Environmental Review Team Report
Poulos Subdivision
Coventry, Connecticut

Environmental Review Team
Report

Poulos Subdivision
Coventry, Connecticut

December 1984

Preliminary Plan

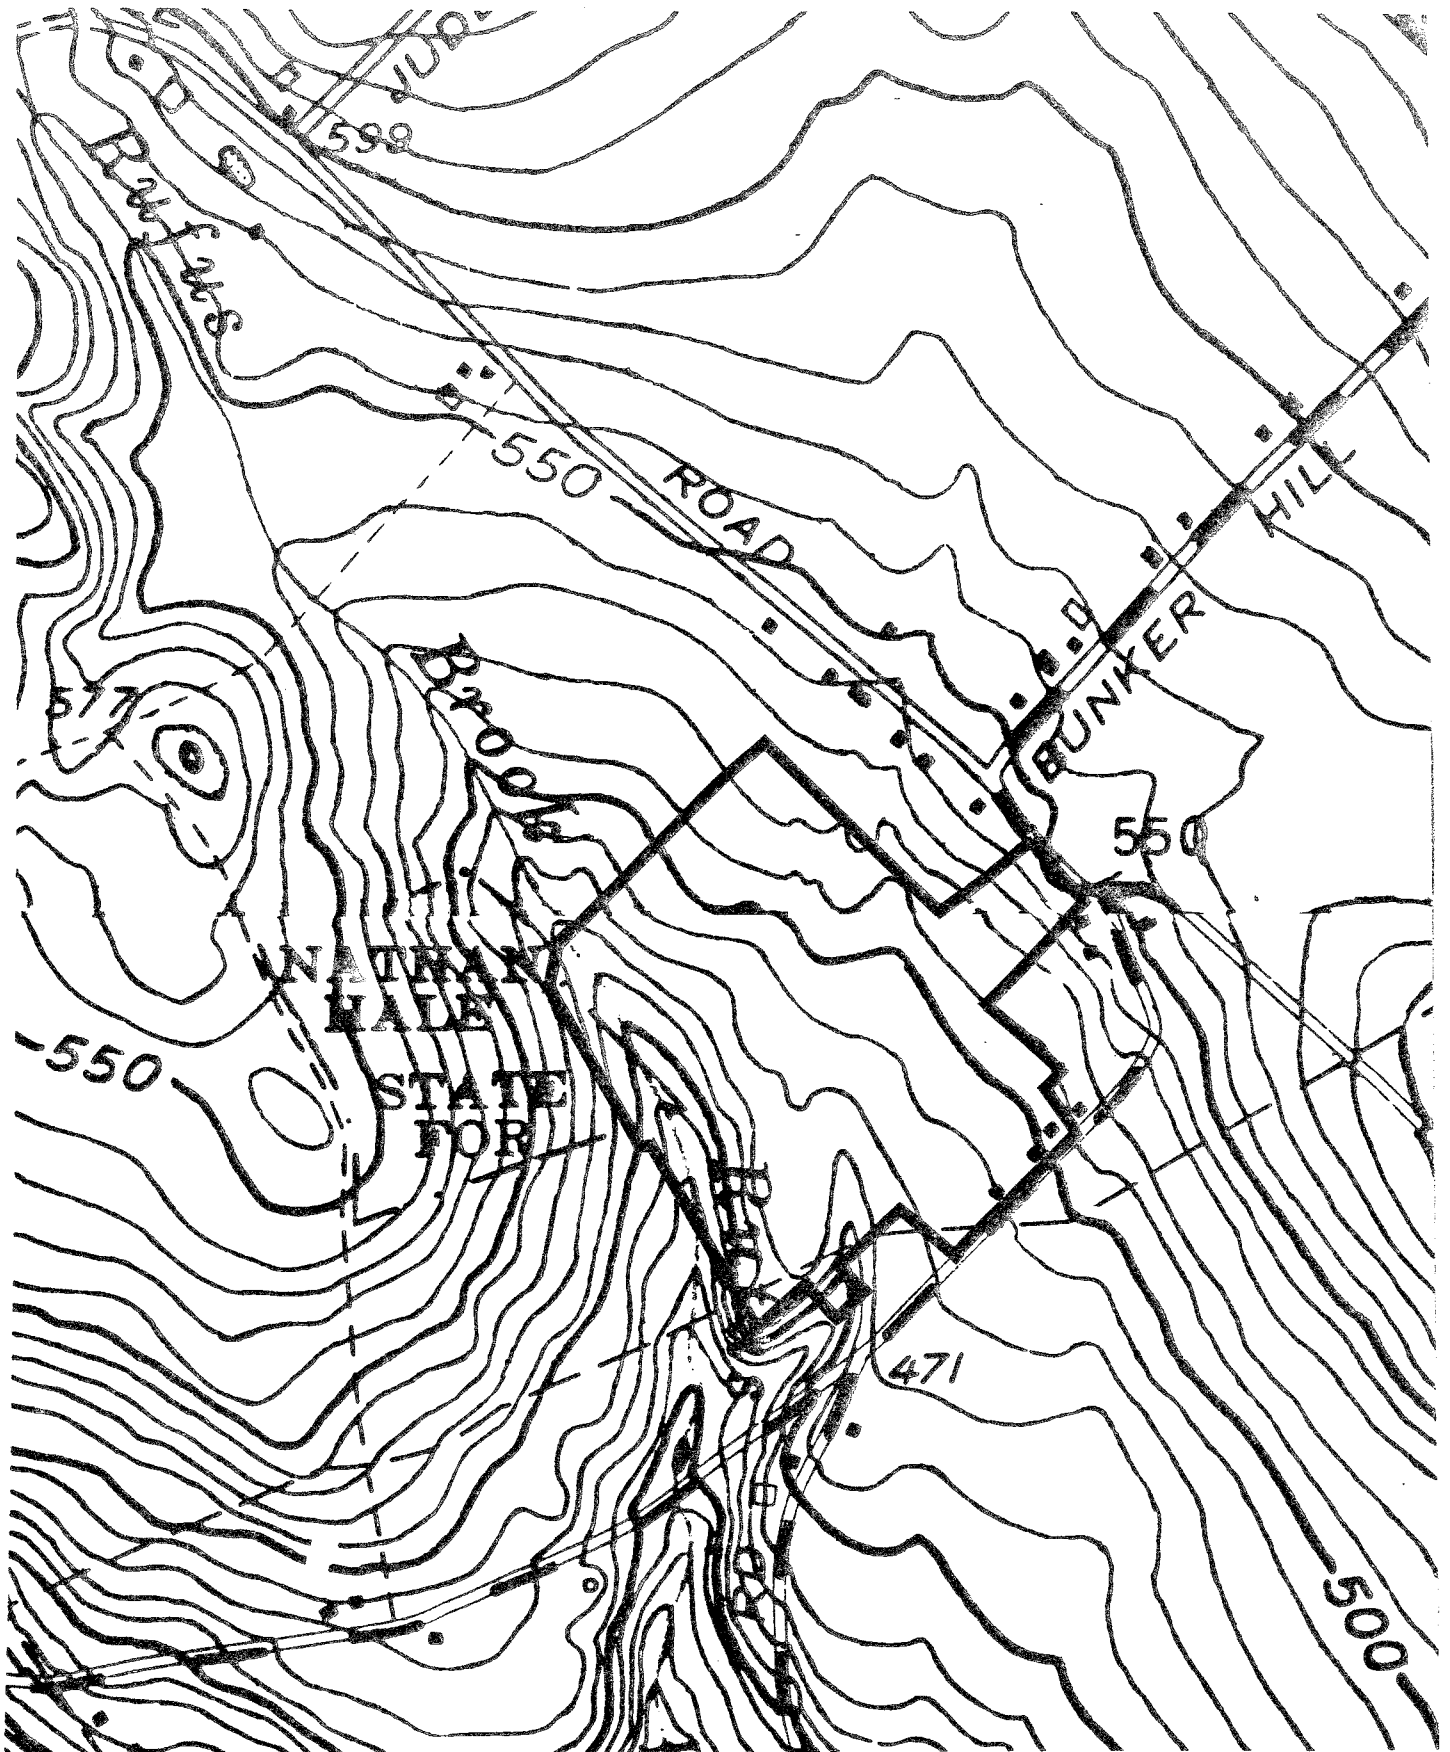
Preliminary plans show 15 lots of 1.39 acres or greater, each. A single road, ending in a cul-de-sac, extends into the site from Bunker Hill Road, providing access to interior lots. Each lot will be served by on-site wells and on-site septic systems. Four bands of wetland soils extend across the site in an east-west direction. The proposed road will cross two of these wetland areas.

A. The Bunker Hill Road Connector to the Route 6 expressway is currently planned to intersect Bunker Hill Road directly across from lot 1 in the Poulos subdivision. Lexington Drive, the proposed cul-de-sac, is proposed to be aligned about two hundred feet northeasterly along Bunker Hill Road from Route 6 expressway connector.

The proposed Bunker Hill Road connector for Route 6 should be indicated on the subdivision map and consideration should be given to increasing the distance between the connector and proposed Lexington Drive to a minimum of 250 feet.

B. The proposed road into the subdivision--Lexington Drive--is a cul-de-sac of approximately 1000 feet in length with twelve of the fifteen proposed lots having frontage on the cul-de-sac.

Coventry's subdivision standards specify cul-de-sac streets "shall generally not exceed six hundred fifty (650) feet in length" (Chapter VI, Section 2 (g)).

A cul-de-sac of 650 feet would terminate in the wetland area that crosses the property. This would be an inappropriate location to place the turning circle of a cul-de-sac.

Some house locations may need to be rearranged, however, to meet setback requirements from wetlands. An intermittent watercourse seems to be present between lots 4 and 5. Section 6.19 of Coventry's Zoning Regulations requires waste disposal systems to be installed 150 feet from the edge of a watercourse and 50 feet from poorly drained soils. These requirements may also affect the proposed house locations for lots 2, 3, 5, 6, 7, 9, 10, 12, and 13 as well as lots 4 and 5.

Drainage Areas

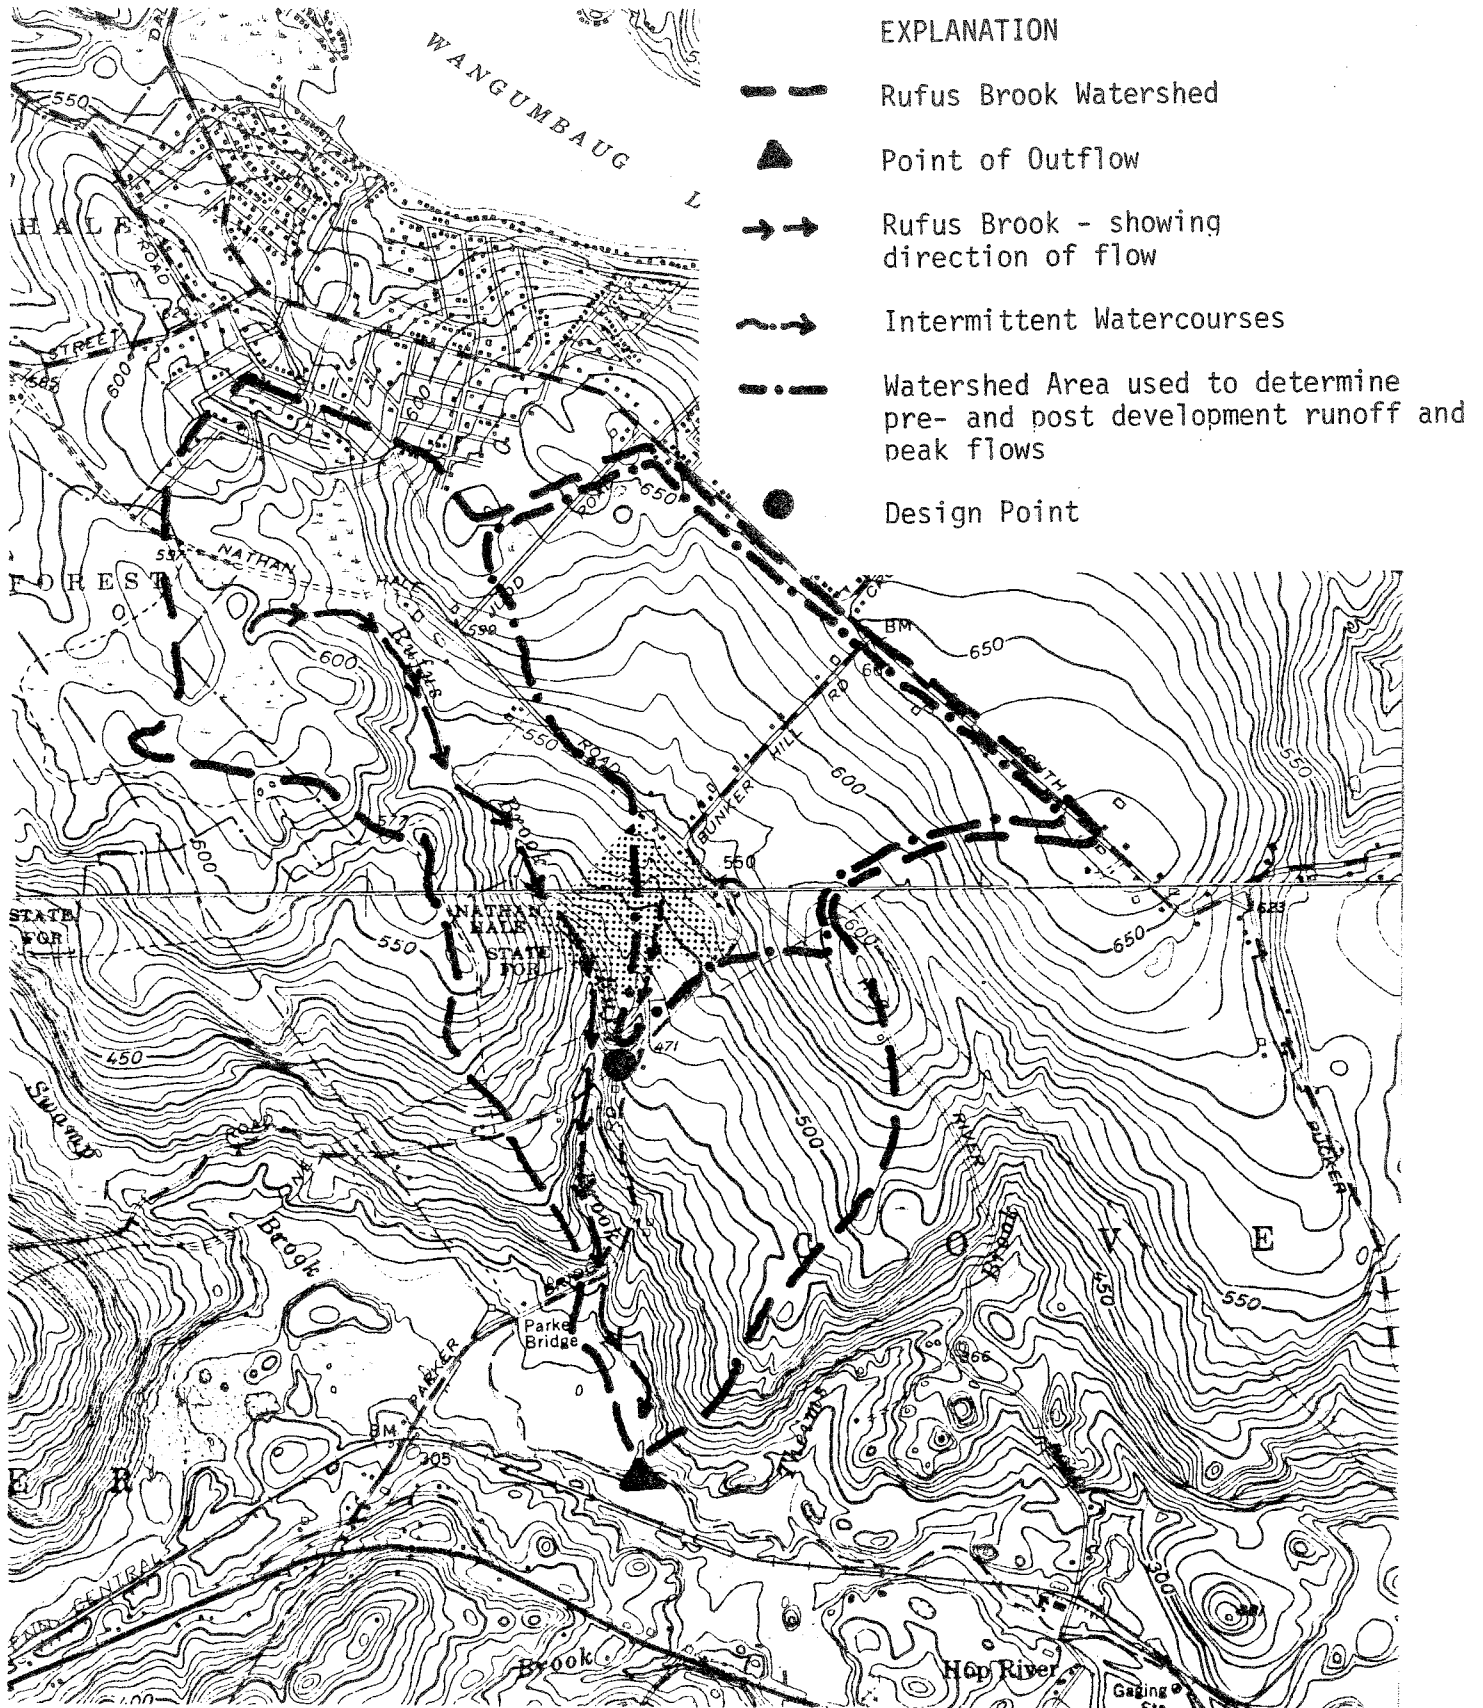
As shown on the accompanying Drainage Area Map, surface runoff from nearly all of the site flows generally southwestward towards Rufus Brook by sheet flow and via the small intermittent streams traversing the parcel. Rufus Brook, whose watershed is approximately 1,100 acres, flows in a southward direction through the western sections of the parcel enroute to the Hop River. The subject parcel represents only 5 percent of the Rufus Brook watershed.

Shown by the accompanying table, peak flow increases at the design point (point of outflow on Rufus Brook) would increase about 4 percent for all storm events. Although these increases are not that high, the increases may cause some additional streambank erosion. It is not expected, however, that the increases would create flooding problems to downstream areas. Since the Town of Coventry requires that post-development flows be maintained at present levels, the applicant's engineer should prepare a stormwater management plan which analyzes pre- and post-development runoff as well as peak flows to Rufus Brook. The plan should be located with the final subdivision proposal so that town officials may review it.
